To: Scott Cleary
Mobility Concepts, Inc.
Scott@mobilityconceptsinc.com

Re: I.O.O.F. Building main floor
replacement framing system

AS-BUILT JANUARY 2016

B.C.I. 6000 1.8 Series

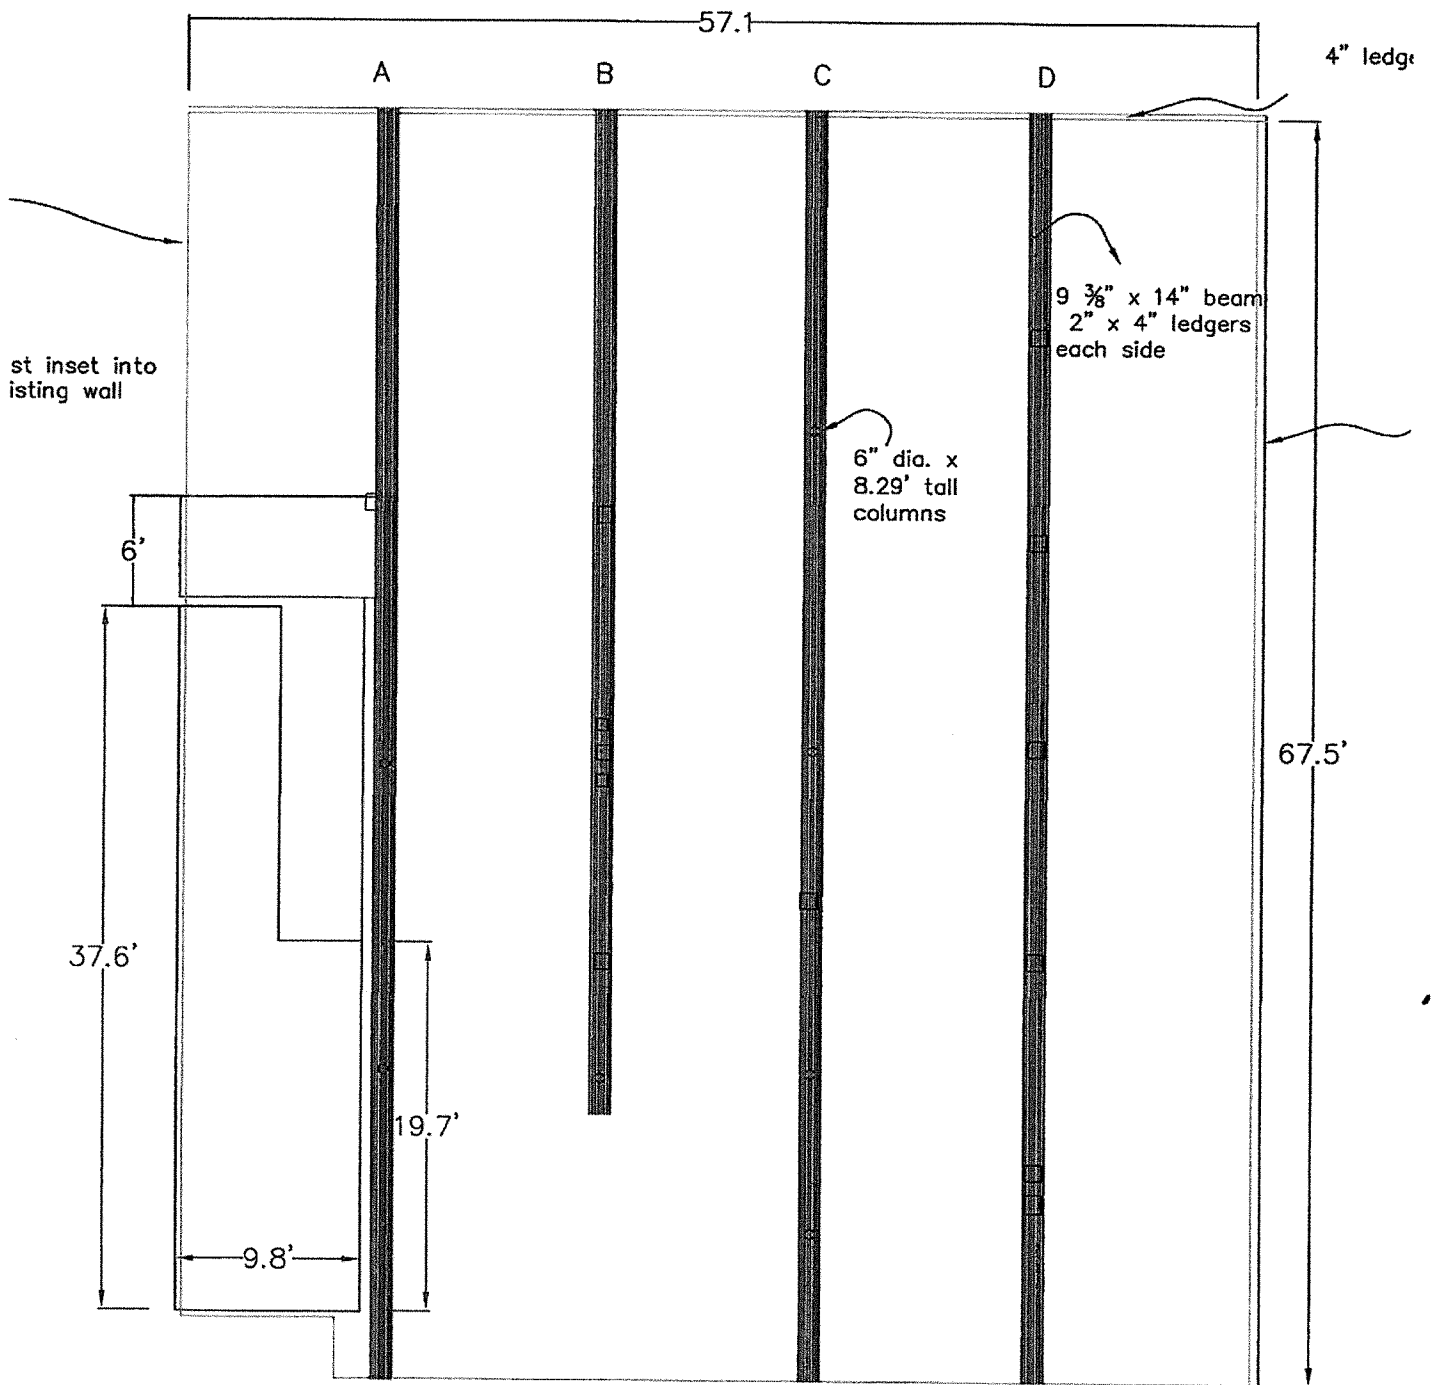
Floor joist calcs:

16" D.C. B.C.I.'s, spanning
≈ 12 ft. from $\pm$ of stud wall
to $\pm$ of stud wall

$$\begin{aligned} & 100 \text{ lb/ft}^2 \text{ L.L.} \\ & + 20 \text{ lb/ft}^2 \text{ struc. D.L.} \\ & \hline & = 120 \text{ lb/ft}^2, \text{ total} \end{aligned}$$

$$\frac{16}{12} \times 120 = 160 \text{ lb/ft on each B.C.I. joist}$$

$$\begin{aligned} \text{Allowable total load} &= 166 \text{ lb/ft} > \\ &160 \text{ lb/ft, O.K.} \end{aligned}$$

$$\frac{160}{166} \times 100\% = 96\% \text{ loaded in total load}$$

$$\text{Allowable L.L.} = > 138 \text{ lb/ft, O.K.}$$

$$\begin{aligned} \frac{133}{> 138} \times 100\% &= < 96\% \text{ loaded in} \\ &\text{L.L.} \end{aligned}$$

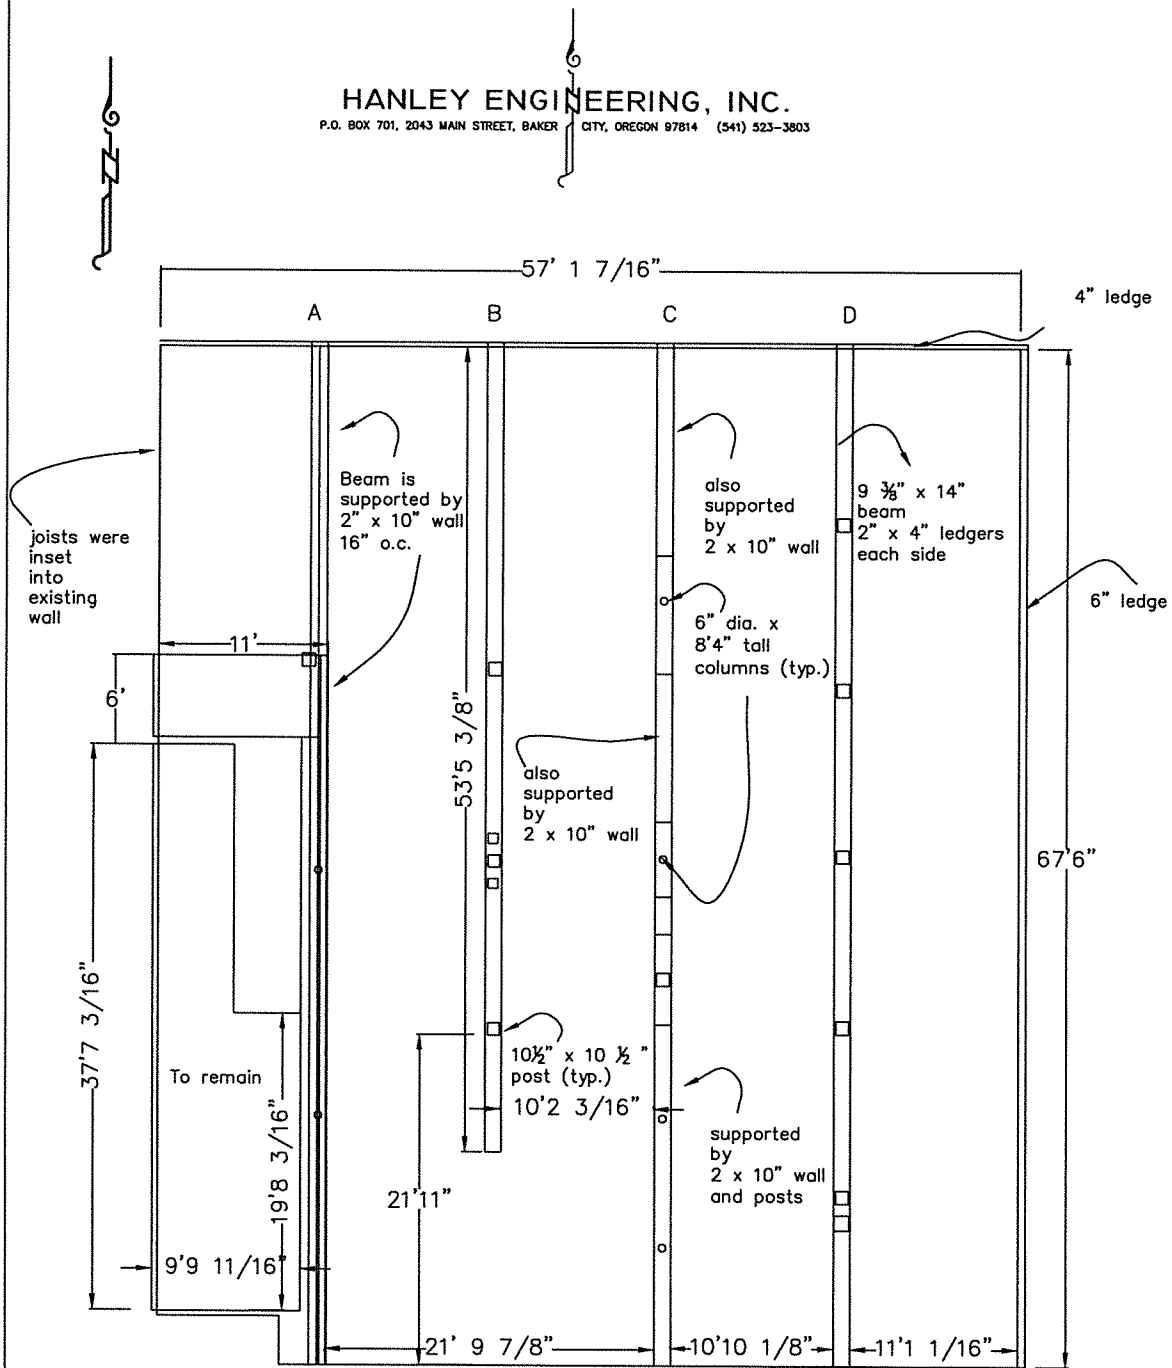
Scott - Here is Dennis as-built
of the present main floor
framing system. To replace all
of the dry-rotted areas of the
main floor, this system will
work:

- 1) Remove the floor joists, beams and columns.
- 2) Leave the concrete footings that are present and in good condition along the N-S beam lines.
- 3) Pour new reinforced concrete footings that are 10" thick x 16" wide along the N-S beam lines and against the East and West exterior walls.

- 4) Build 6 N-S oriented stud walls using 2x6 D.F. studs @ 16" O.C. Bottom plate (mud sill) 2x6 P.T. Hem-Fir w/ $\frac{5}{8}$ " A.B.'s cast-in-place @ 4 ft. O.C. Double top plate to carry new B.C.I. floor joists.
- 5) Sheath the new stud walls w/ $\frac{7}{16}$ " OSB or $\frac{1}{2}$ " CDX plywood, nailed w/ #8 common, edge nailing @ 4" O.C. $\frac{1}{2}$ field nailing @ 8" O.C., all edges blocked
- 6) New floor joists B.C.I. 6000 1.8 Series, blocked over every bearing location. Use full-length, S-span floor joists, if available that long.
- 7) New subfloor is $1\frac{1}{8}$ " CDX or plywood T & G Sturd-I-Floor. Butt joints staggered, glued & screwed.
